Mayer Community Center – Council Chambers - 413 Bluejay Avenue, Mayer, MN 55360

**PLANNING COMMISSION
REGULAR MEETING**

**Coldwater Crossing 8th Addition Final Plat, Final Planned Unit Development (PUD)
Plan and Right of Way Vacation**

Meeting Date: November 15, 2018
Applicant/Owners Coldwater X, LLC - Attn: Jude Lague
Address/Location: Located north of the existing Coldwater Crossing Development

Exhibit B - Preliminary Plat of Coldwater Crossing 8th Addition dated 8-3-18

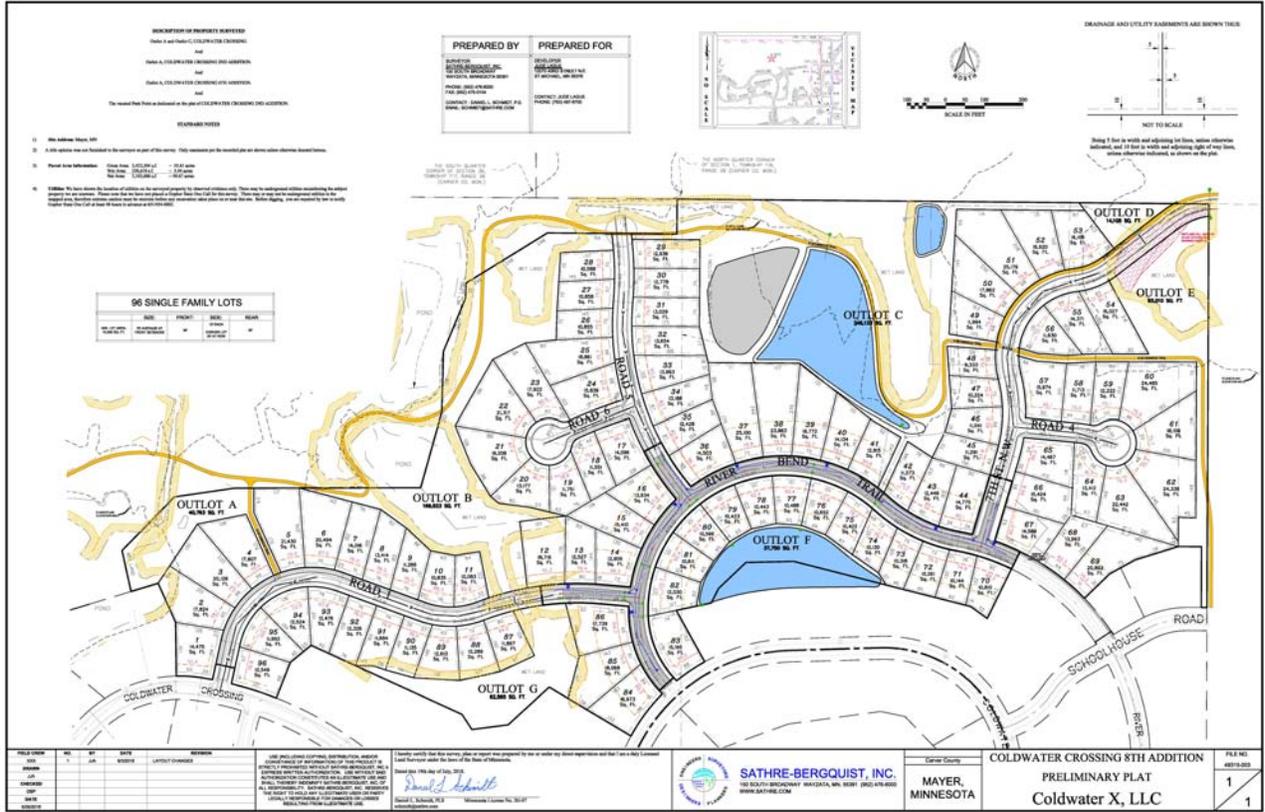
As shown in the preliminary plat, the developer is dedicating six of the seven outlots in the preliminary plat to the City for open space and stormwater ponding purposes. The total acreage of these outlots is 17.221 acres, well above the 8% requirement of 4.449 acres. It needs to be determined if these outlots are going to be dedicated at this time or if they will be dedicated in future phases.

Street Names: On the final plat of Coldwater Crossing 8th Addition there are three streets that are named Road 1, Road 3 and Road 5. These streets will need names shown on the final plat and this will be a condition of approval. Future street extension signs will be required to be placed at the end of all three of these streets.

Easement: There is a 16.5 foot wide easement on the north boundary of the plat. This easement was shown on the final plat for Coldwater Crossing across Outlots A & C and on the final plat for

Coldwater Crossing 2nd Addition across Outlot A. The preliminary plat shows a storm water pipe in this area as well as ponding in this area. This easement should be vacated with the final plat approval for Coldwater Crossing 8th Addition.

2. Park Dedication. There shall be no required park dedication with this plat.
3. Street Names. On the final plat of Coldwater Crossing 8th Addition there are three streets that are named Road 1, Road 3 and Road 5. Street names will be required as a condition of approval.

17. Easement Vacation. The easement on the north property line of the plat shall be vacated at the same time as the final plat approval of Coldwater Crossing 8th Addition.

Exhibit D - Wetland Delineation Map dated 6-17-18

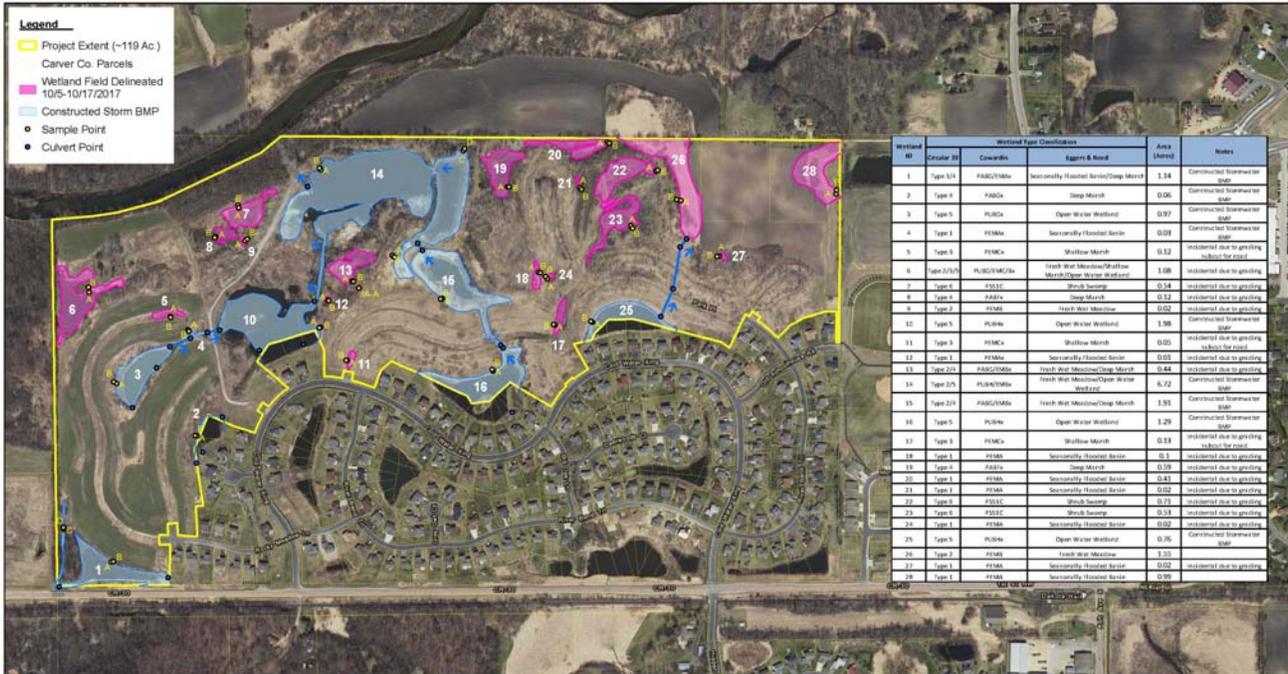
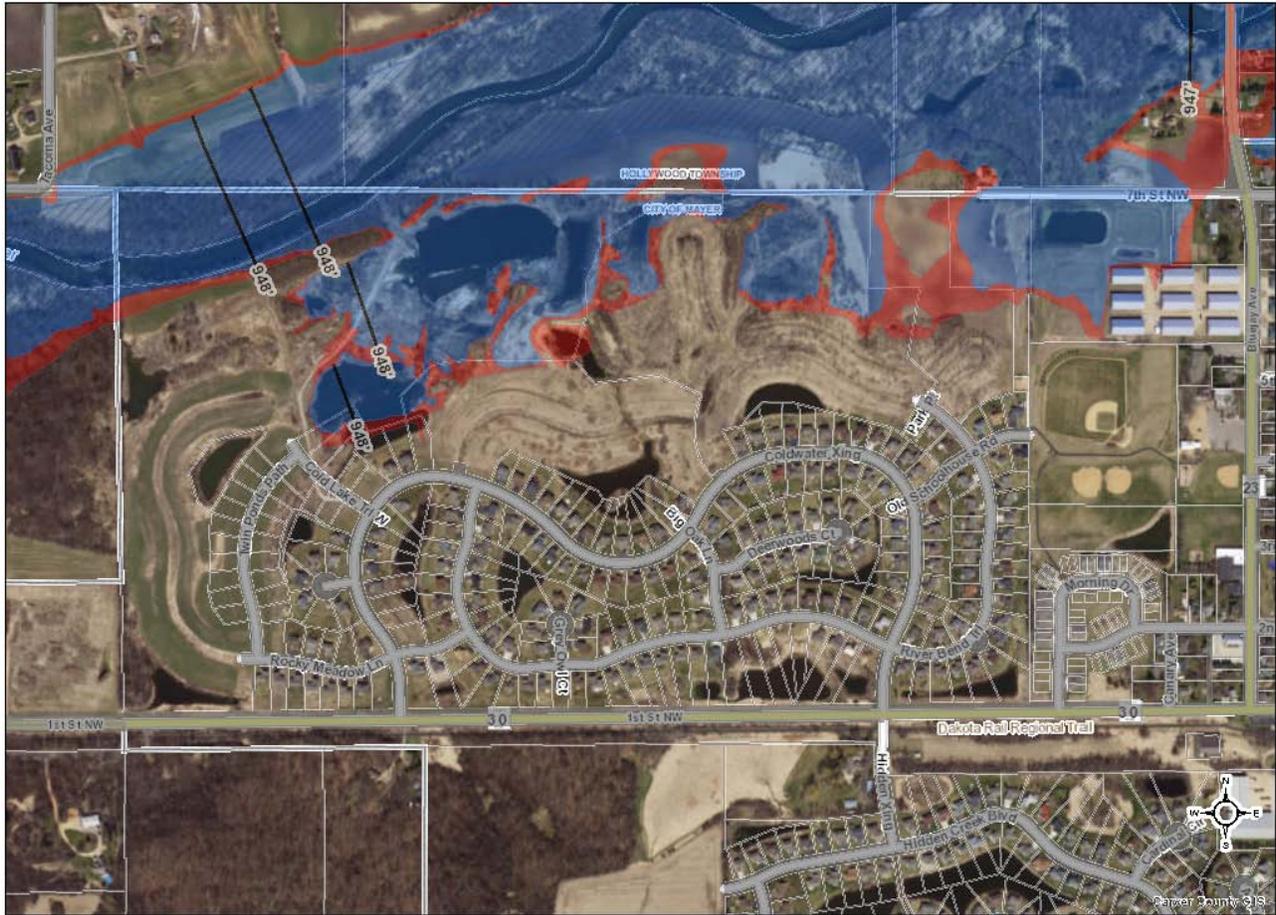
A condition of approval for Coldwater Crossing 7th Addition was that when a preliminary plat for Coldwater Crossing 8th Addition was submitted, a wetland delineation for the entire remaining undeveloped property in Coldwater Crossing was to be required. As part of this submittal, a wetland delineation was completed for this area. As part of this delineation 28 wetlands were delineated and have been verified. It is expected that some of these wetlands will be incidental and exempt since they were created as part of the original grading of Coldwater Crossing. There are also some impacts shown in some of the wetlands. A few of these impacts may be exempt due to previous grading but it appears two impacts will need to be mitigated for or credits will need to be purchased if the impacts are approved. One impact is to wetland 28 in the very northeastern corner of the property to allow for 7th Street NW to be extended to the property line. It appears this impact could be minimized but any impact here would have to go through the Minnesota Wetland Conservation Act review process. The other impact proposed is for the trail connection to Road 5. In this case the trail is located in a wetland. It is possible that the trail could be moved to the south to miss the wetland but that would mean the loss of a lot. Both of these impacts are not part of the Coldwater Crossing 8th Addition final plat and it will have to be determined if the applicant applies for the wetland impacts with this final plat or with a future final plat.

In addition to approval the Minnesota Wetland Conservation Act, review and approval of any impacts will also be needed by the Army Corp of Engineers. It would first need to be determined what wetlands are under Army Corp approval and if any of those wetlands are to be impacted. Prior to final plat approval by the City Council, wetland approvals will be required from both the Army Corp and through the Minnesota Wetland Conservation Act, unless it is determined that the impacts replacement plans can be submitted with future phases of Coldwater Crossing when the wetlands will actually be impacted.

7. Wetland Impacts. Approval of all wetlands impacts will be required through the Minnesota Wetland Conservation Act. This approval will not be required until that phase is being final platted.

8. No Loss Exemption. A No Loss Exemption may be required due to the fact the constructed stormwater ponds that were previously graded may now considered wetlands.

9. Army Corp of Engineers Approval. In addition to the Minnesota Wetland Conservation Act approval process, approval of any wetland impacts, exemptions, etc. shall be required from the Army Corp of Engineers. This approval will not be required until that phase is being final platted.

Exhibit E - Floodplain Map

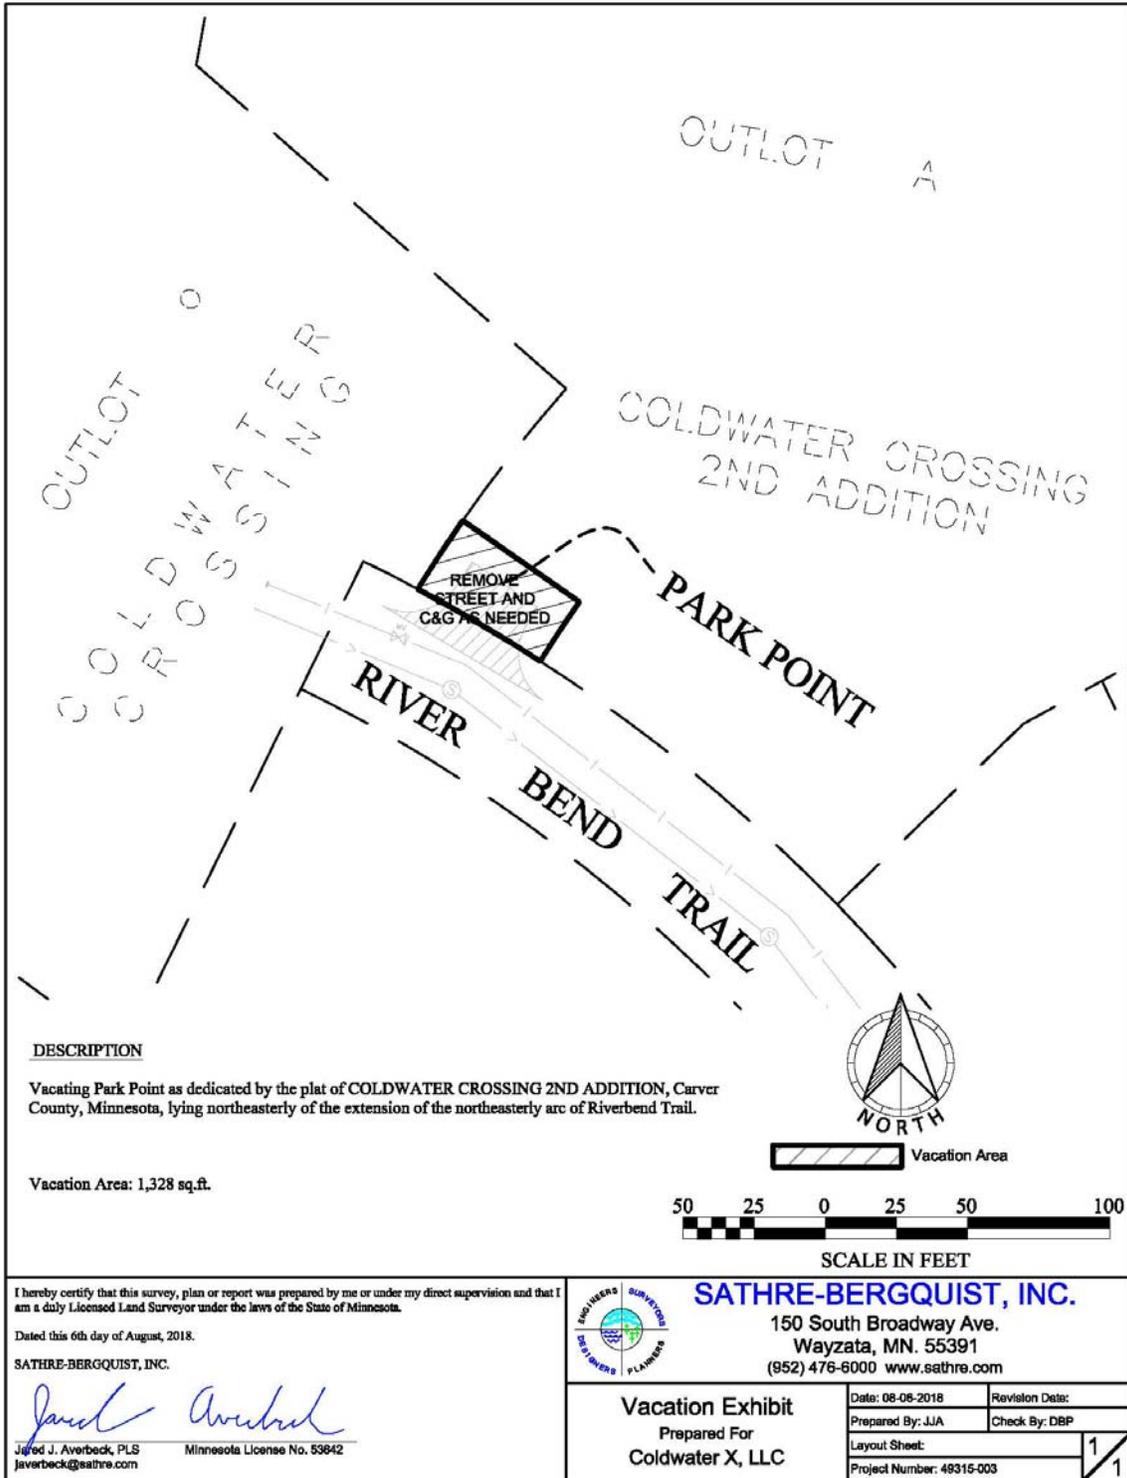
- Floodplain:** There is floodplain that is located throughout this plat. It is proposed that areas located in the preliminary plat will fill the floodplain so those areas will need a Letter of Map Amendment (LOMA). It will have to be verified if any of those fill areas are located in the final plat for Coldwater Crossing 8th Addition. If filling is occurring, the LOMA will be needed prior to final plat approval by the City Council. This means the applicant will have to show that they are replacing the filled areas with other areas for floodplain storage. In order to accomplish that the grading plan will need to indicate this to the satisfaction of the City Engineer

12. Floodplain. That the floodplain boundaries are shown on the preliminary plat and that all floodplain areas are located either in a outlot or drainage and utility easement. Any floodplain proposed to be filled will require approval of a Letter of Map Amendment (LOMA) from FEMA.
